Consultation Response KC Landscape

Planning Number:	2025/91184		
Proposal:	Erection of two storey industrial unit (Use Class E(g)(iii)), with associated car park, service area and other associated works		
Location:	land off, Bretton Street, Savile Town, Dewsbury, WF12 9BZ		
DEVELOPER/APPLICANT/AGENT:	Jade3 Architecture		
Planning Officer:	Jillian Rann		
Date Responded:	20.08.2025	Responding Officer:	Landscape
Site Area (Hectares)		Responding Ref:	PP34

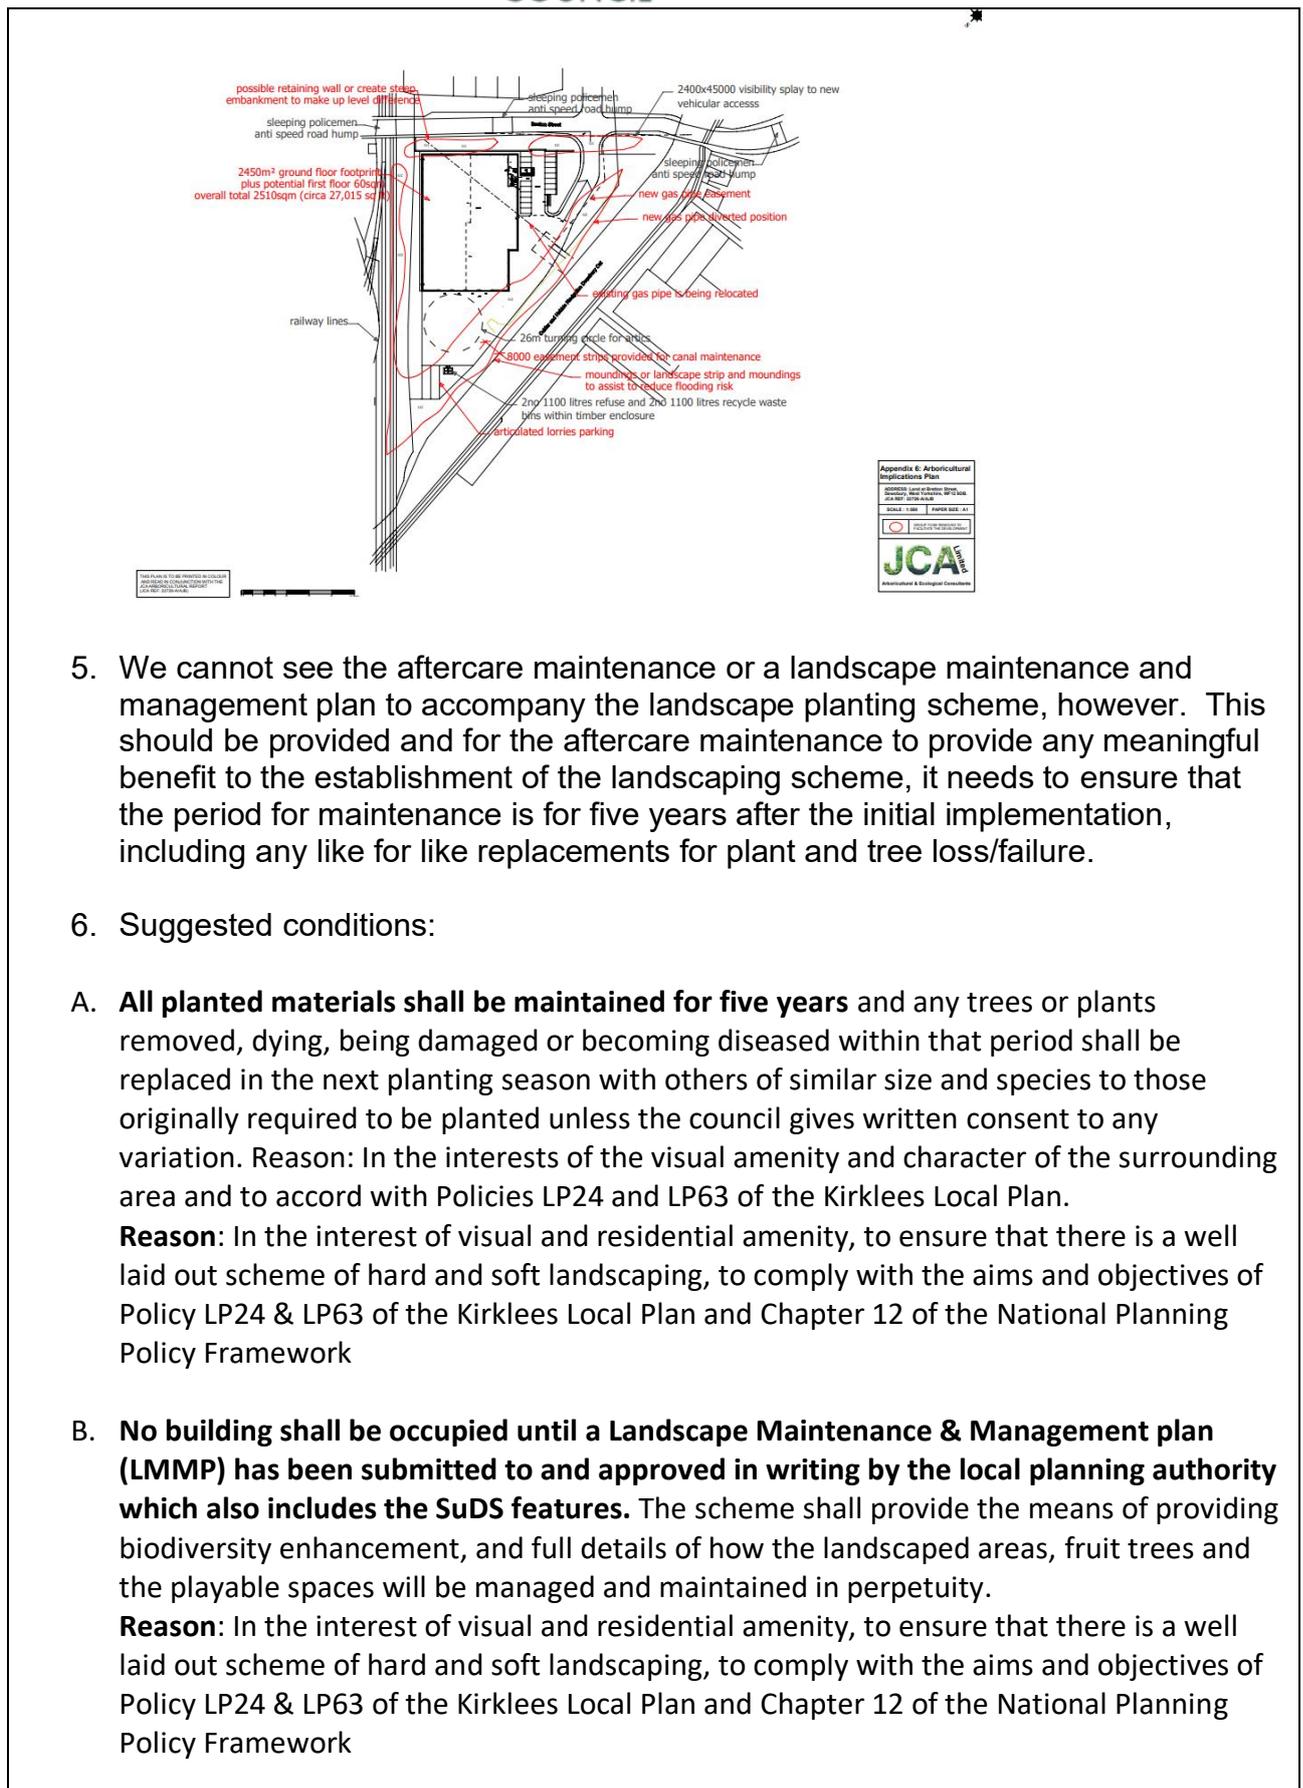
1. Most of the landscape information that has been provided is fine and we welcome the use of native species in this location.
2. We note that gaps have been for canal access with the trees placed in groups so that they can negotiate the canal around them.

3. Will there be any trees retained along the Canalside? Potentially due to new gas alignment/ easement?

4. Confirmation required that new tree planting will not be adversely affected/necessitate removal by this easement.

5. We cannot see the aftercare maintenance or a landscape maintenance and management plan to accompany the landscape planting scheme, however. This should be provided and for the aftercare maintenance to provide any meaningful benefit to the establishment of the landscaping scheme, it needs to ensure that the period for maintenance is for five years after the initial implementation, including any like for like replacements for plant and tree loss/failure.

6. Suggested conditions:
 - A. **All planted materials shall be maintained for five years** and any trees or plants removed, dying, being damaged or becoming diseased within that period shall be replaced in the next planting season with others of similar size and species to those originally required to be planted unless the council gives written consent to any variation. Reason: In the interests of the visual amenity and character of the surrounding area and to accord with Policies LP24 and LP63 of the Kirklees Local Plan.
Reason: In the interest of visual and residential amenity, to ensure that there is a well laid out scheme of hard and soft landscaping, to comply with the aims and objectives of Policy LP24 & LP63 of the Kirklees Local Plan and Chapter 12 of the National Planning Policy Framework

- B. **No building shall be occupied until a Landscape Maintenance & Management plan (LMMP) has been submitted to and approved in writing by the local planning authority which also includes the SuDS features.** The scheme shall provide the means of providing biodiversity enhancement, and full details of how the landscaped areas, fruit trees and the playable spaces will be managed and maintained in perpetuity.
Reason: In the interest of visual and residential amenity, to ensure that there is a well laid out scheme of hard and soft landscaping, to comply with the aims and objectives of Policy LP24 & LP63 of the Kirklees Local Plan and Chapter 12 of the National Planning Policy Framework

C. Rootspace engineered tree pits: The installation of root space engineered tree pits and specified trees below hard surfacing shall be monitored by the manufacturer and a letter confirming monitoring of, and satisfactory installation of the trees, as per the landscape scheme drawings shall be submitted on completion of the same to and approved in writing by the Local Authority.
